**SUBJECT: OYSTER CREEK GENERATING STATION (OYSTER CREEK)
OPERATING LICENSE NO. DPR-16
DOCKET NO. 50-219
RESPONSE TO REQUEST FOR ADDITIONAL INFORMATION -
RADIOLOGICAL CONSEQUENCE ANALYSIS FOR CONTROL ROOM
OPERATORS AT OYSTER CREEK GENERATING STATION
(TAC NO. MA3465)**

Enclosed is the AmerGen Energy Company, LLC (AmerGen) response to the NRC request for additional information, dated October 10, 2000, regarding implementation of alternate source term for control room habitability.

RESPONSE TO REQUEST FOR ADDITIONAL INFORMATION

Figure 1
Integrated Aerosol Mass Leaked Out Through One Inboard MSIV
(No Collection DF Being Applied)

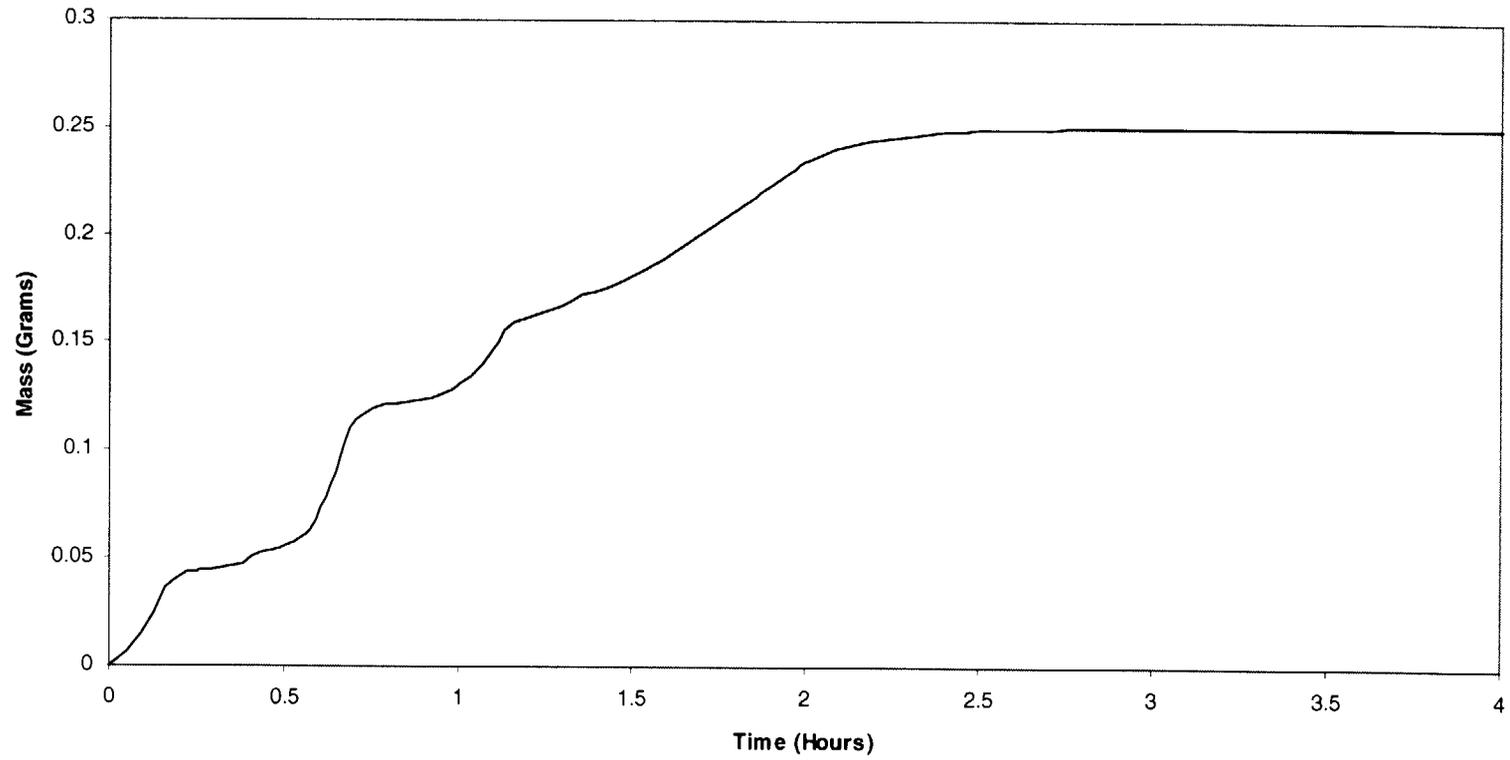
- Provide detailed technical justifications and references used for estimating aerosol impaction (decontamination factor of 2) at the inboard main steam isolation valve (MSIV) in the steam line with one open MSIV; and
- Describe in detail the STARNAUA model used for estimating aerosol sedimentation between the other steam line's closed MSIVs and provide the aerosol removal coefficients calculated with STARNAUA.

Using the above expression with the most conservative value for K, the leak path would be plugged when $5.9\text{E-}3$ grams of aerosol has leaked through the single orifice. On Figure 1, which represents the mass leaked out through one MSIV as a function of time without plugging being considered, one can see that the total leaked mass per MSIV would be about 0.25 grams if plugging were neglected. Therefore, the actual effective DF due to leak path plugging would amount to about 40 (i.e., $0.25 \text{ grams}/0.0059 \text{ grams}$). It is noteworthy that the leak path would be plugged very early into the event, as $5.9\text{E-}3$ grams of aerosol would have leaked through the hypothetical MSIV leak orifice in only 180 seconds.

The effect of plugging would be greater than just a DF for the aerosol release; it might actually affect the rate of gaseous iodine and noble gas release, as well. These effects are ignored, however. Instead, only a DF of two on the aerosol (and on the elemental iodine which is assumed to be adsorbed on the aerosol is credited (Reference response to NRC Question No. 4).
